ADDENDUM 1 (PENDING DSA APPROVAL)

PROJECT: **Santa Ana College**
 Science Center

DATE: 8/23/2017

DSA File No.: 30-C2
DSA Applications No.: 04-115788
HGA Commission No.: 3584-001-00

A422

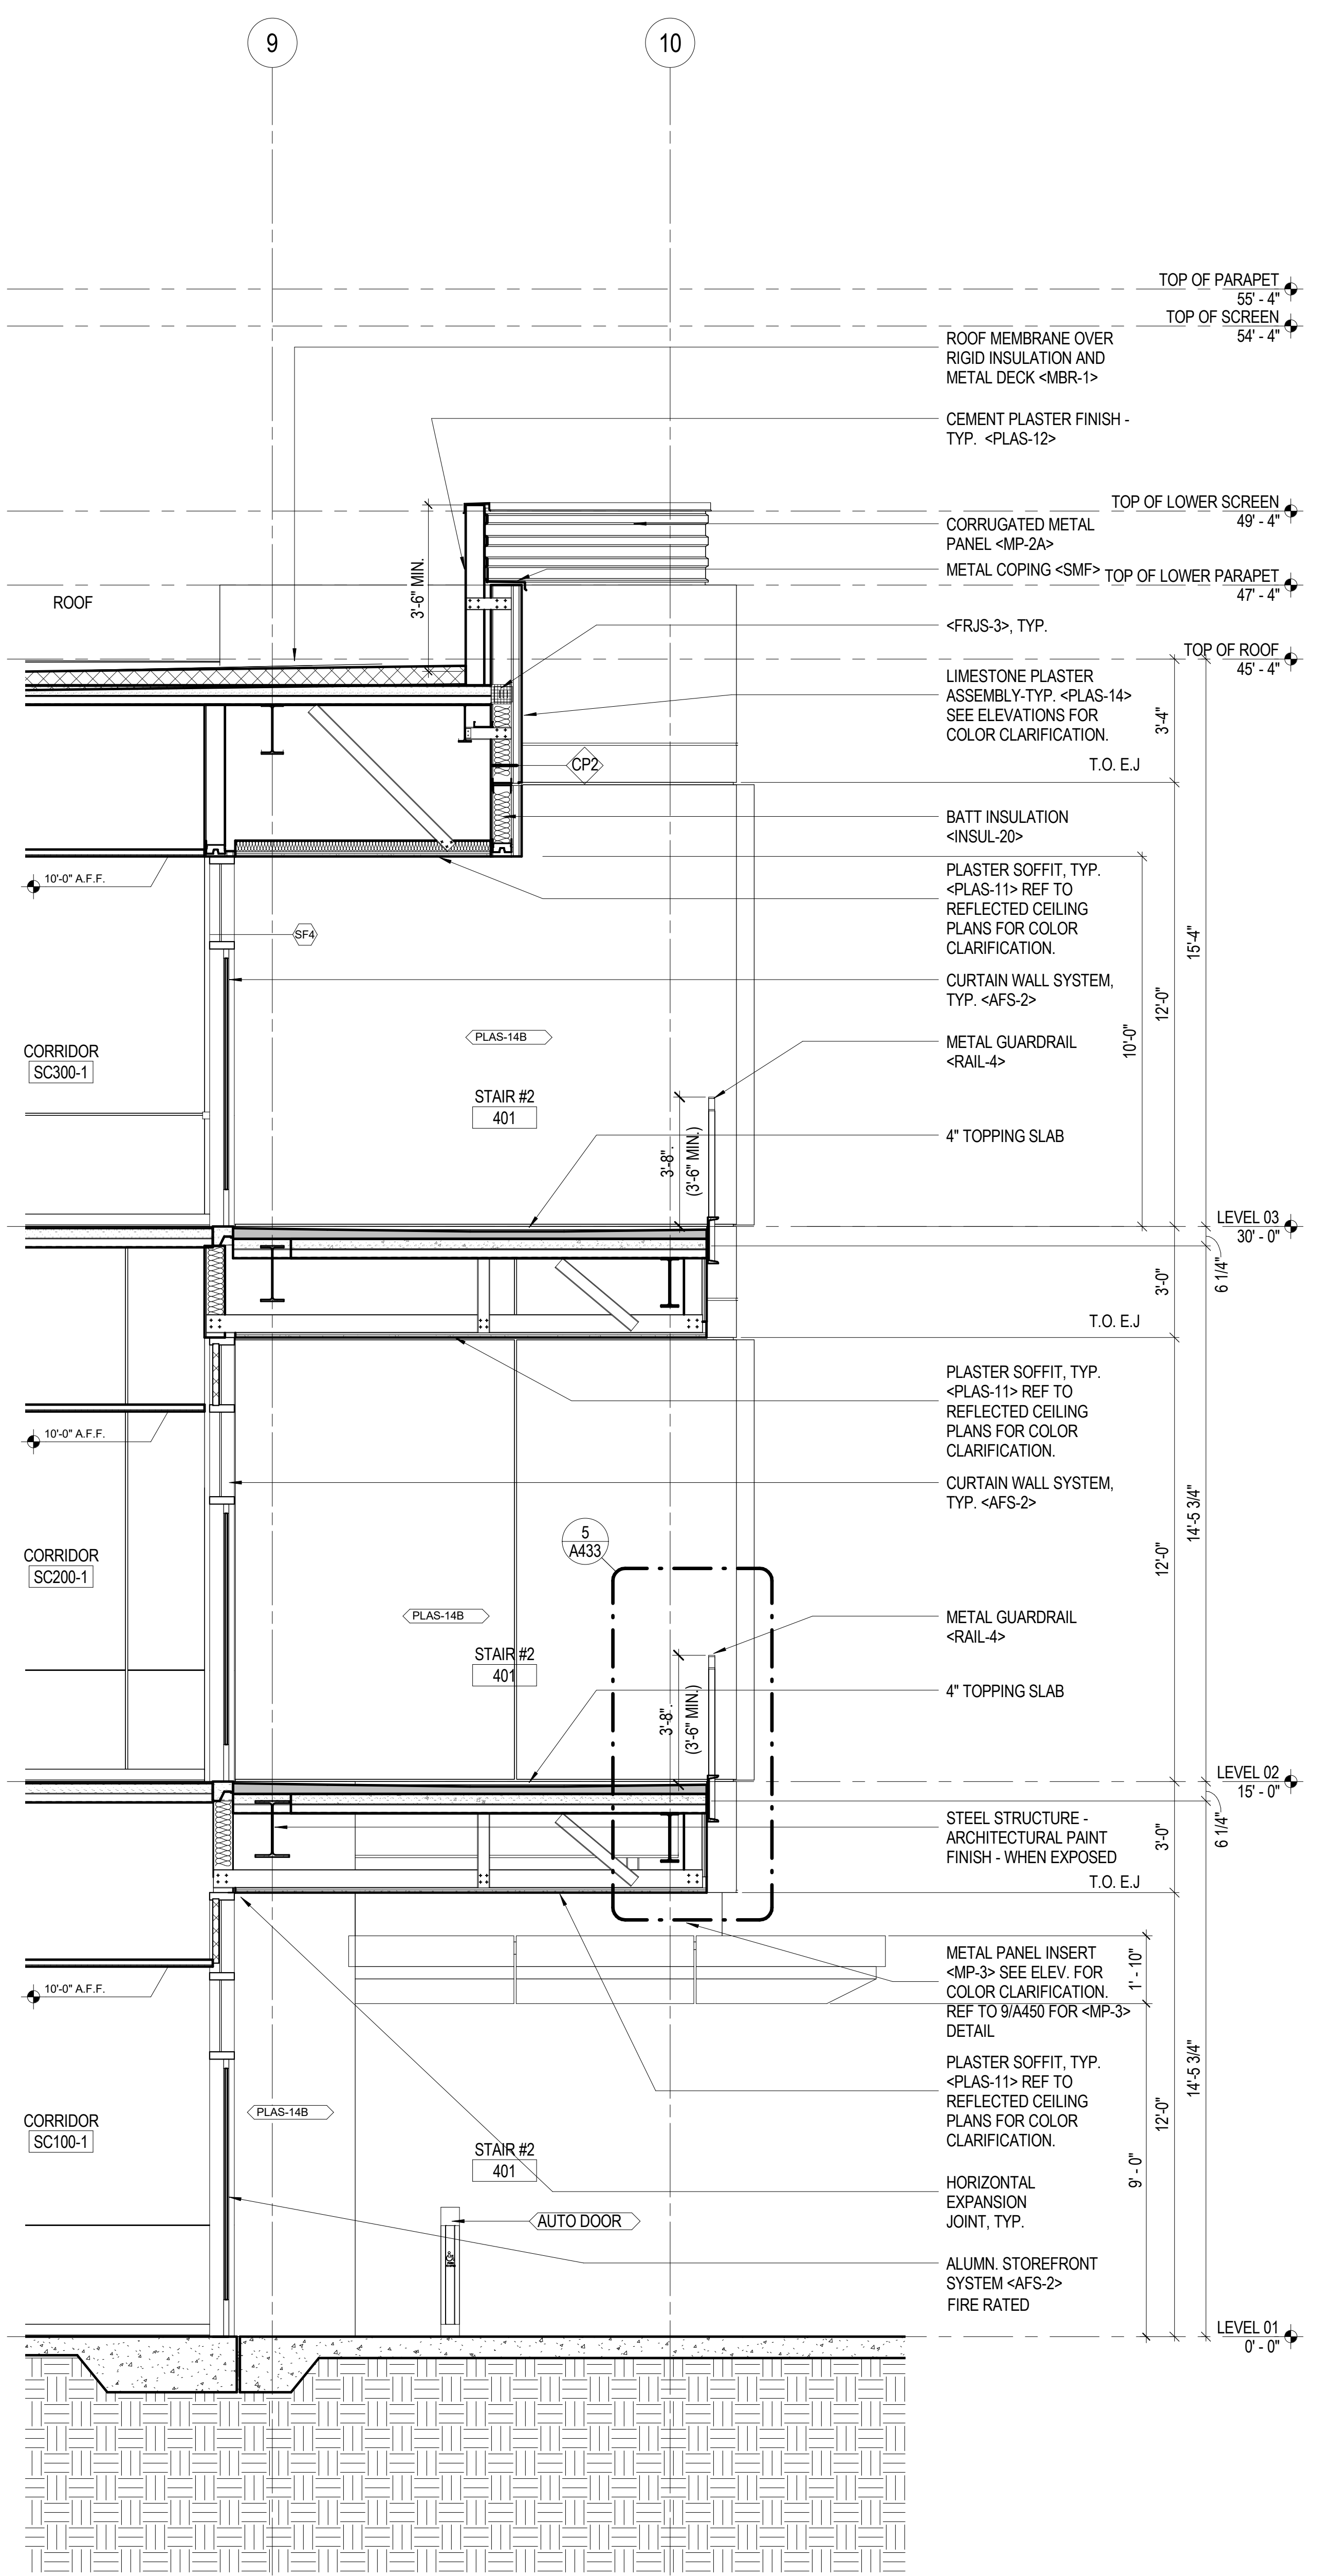
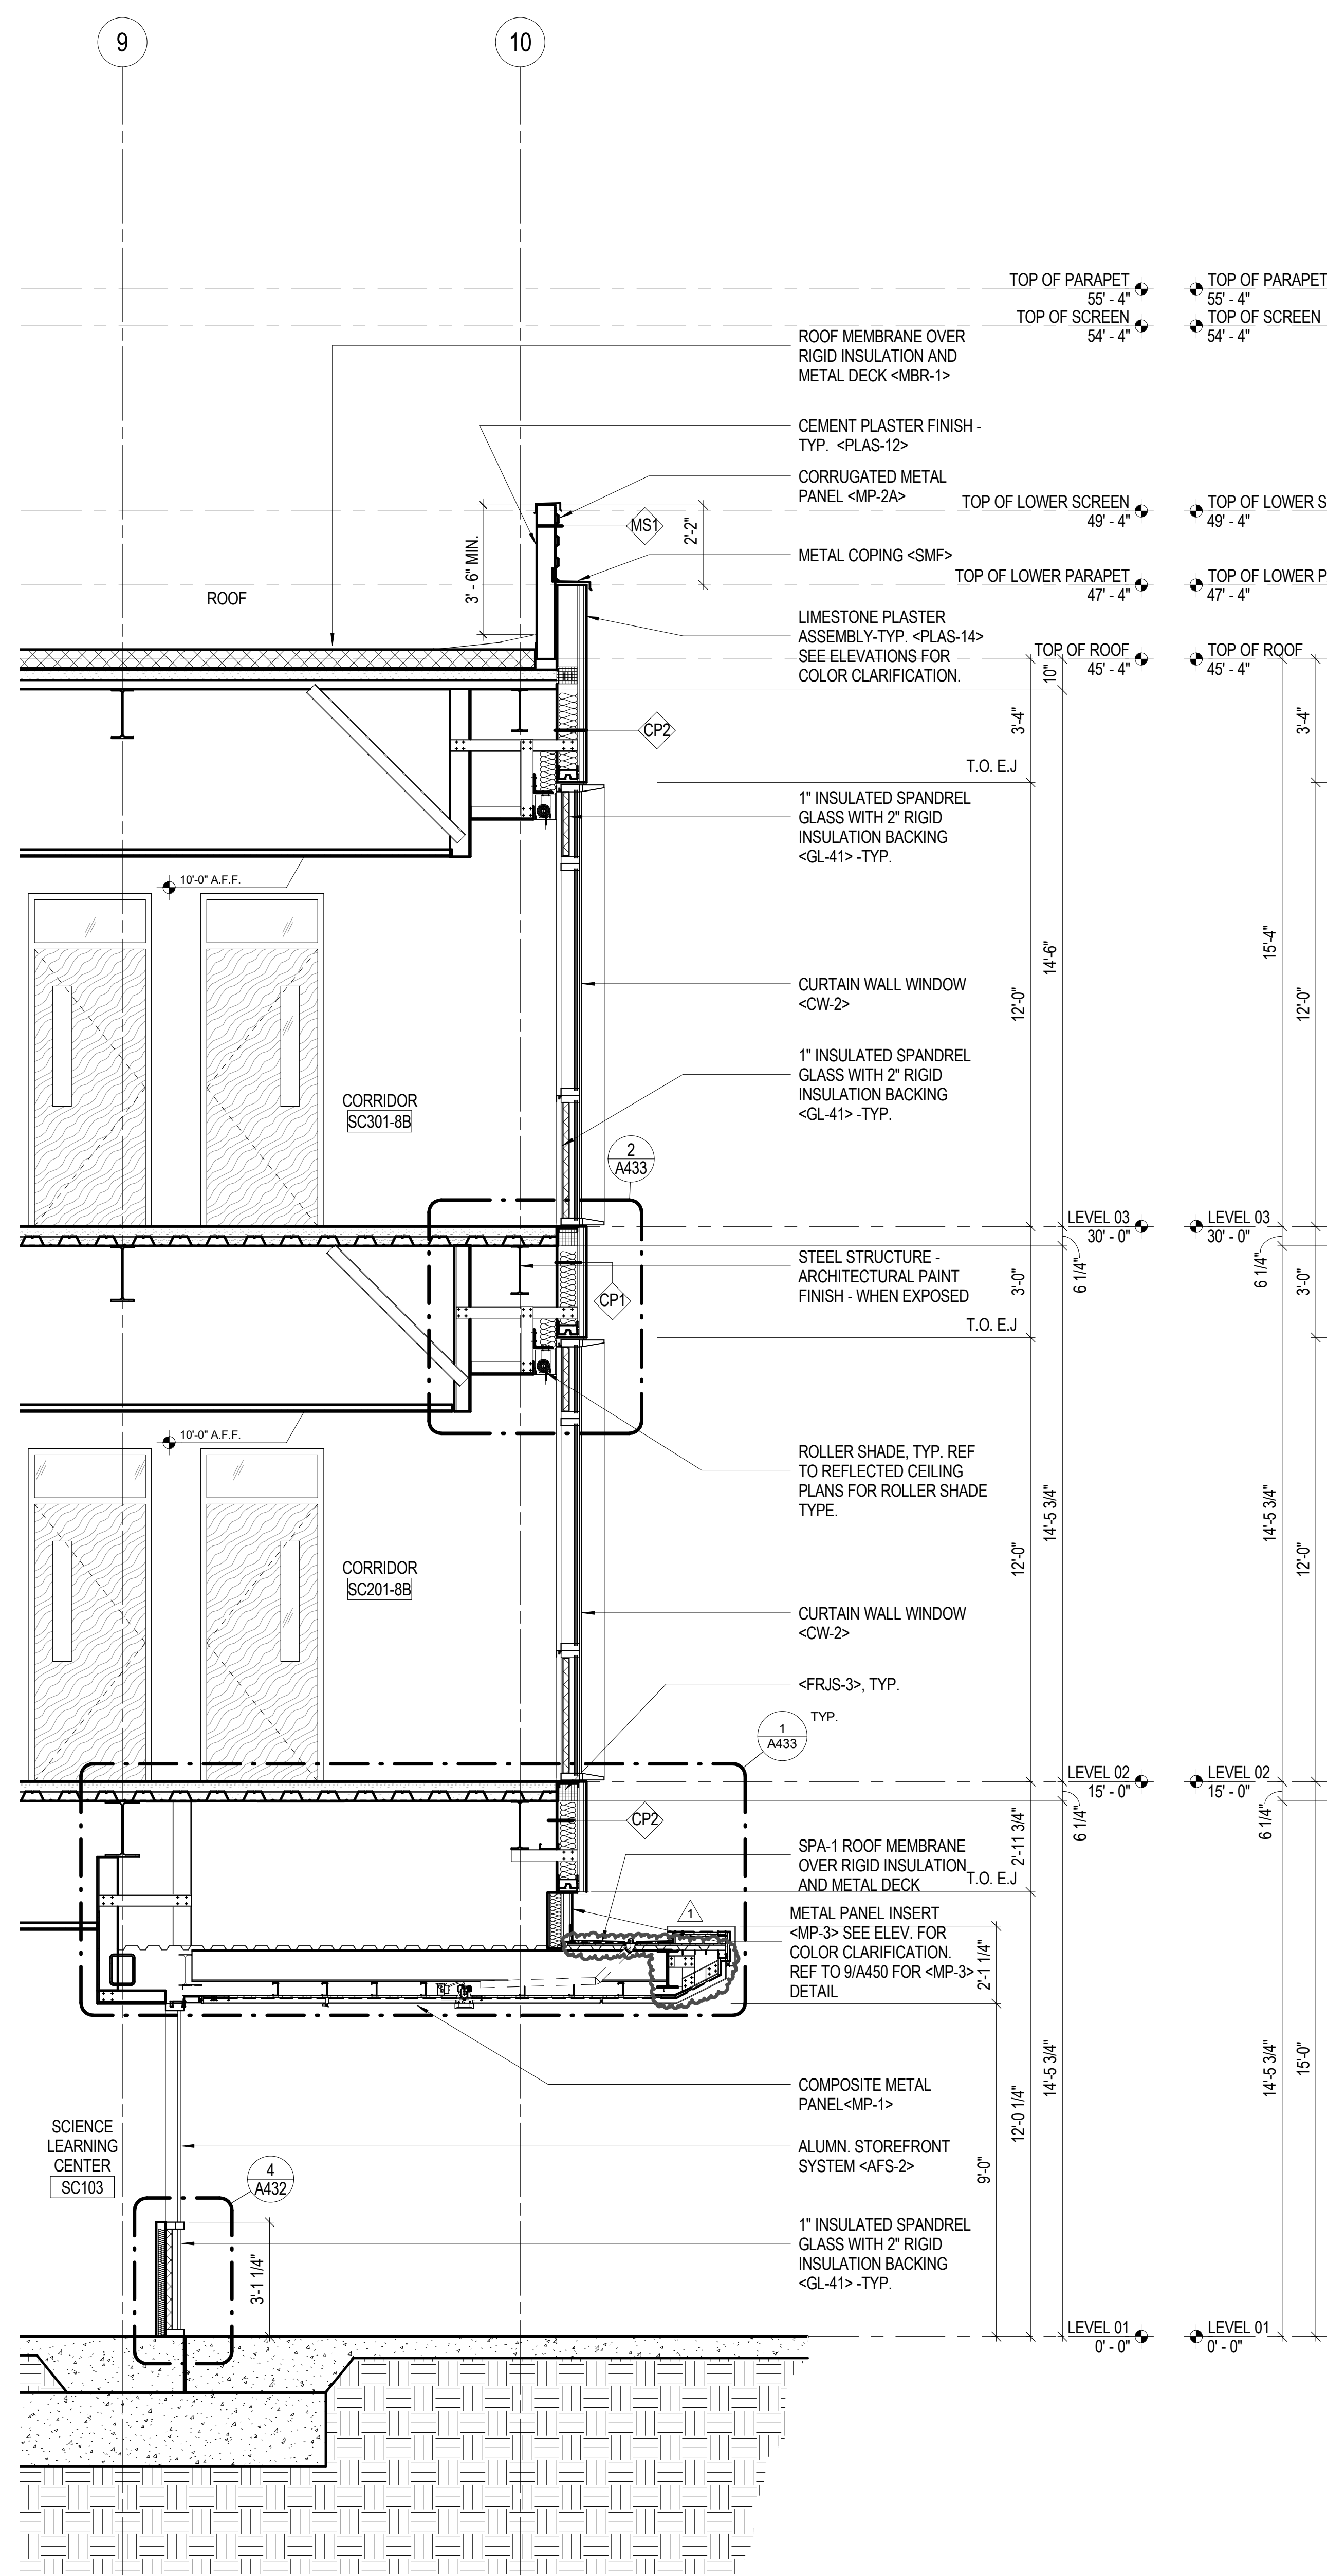
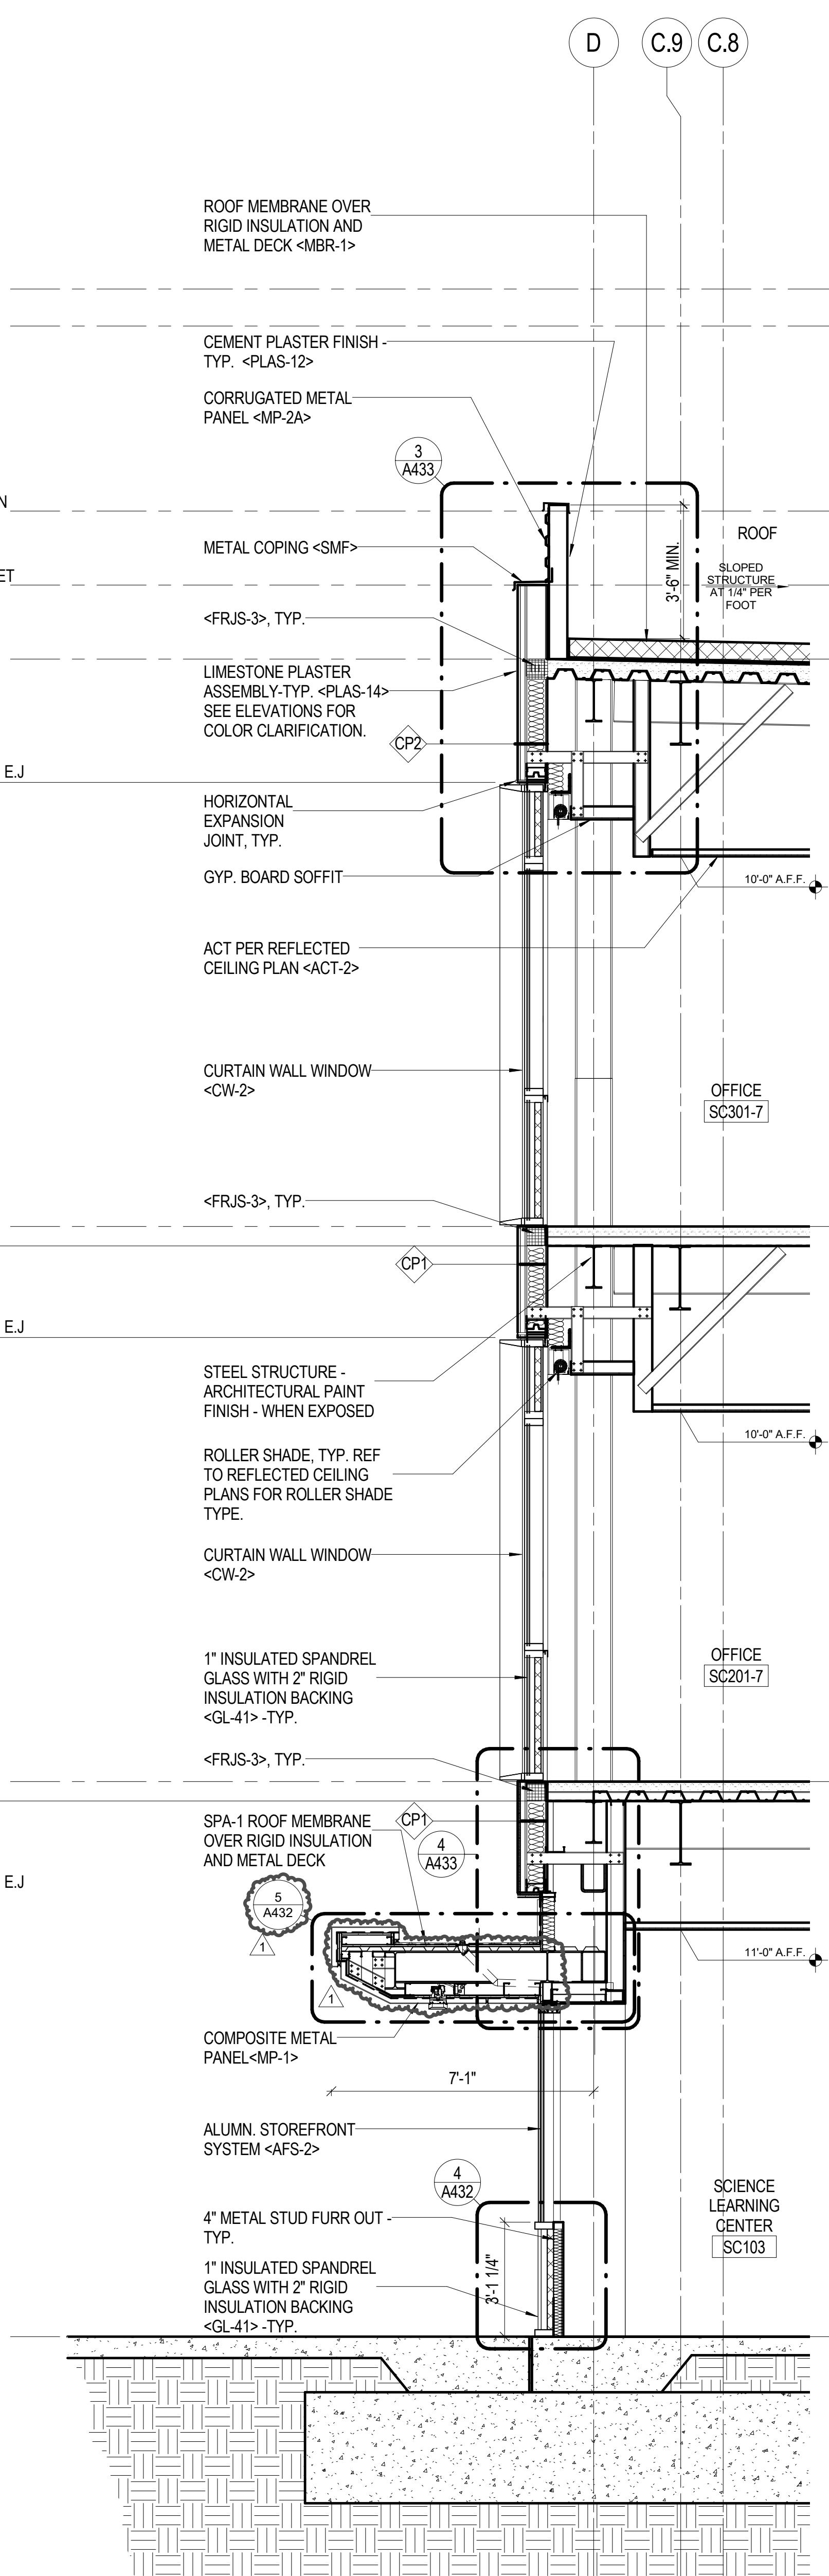
- North canopy reduced by 5'-0" at Details 1, 2, and 3.
- Gutter removed from roof at north canopy at Details 1, 2, and 3.
- Framing at canopy revised to match structural drawings at Details 1 and 2.
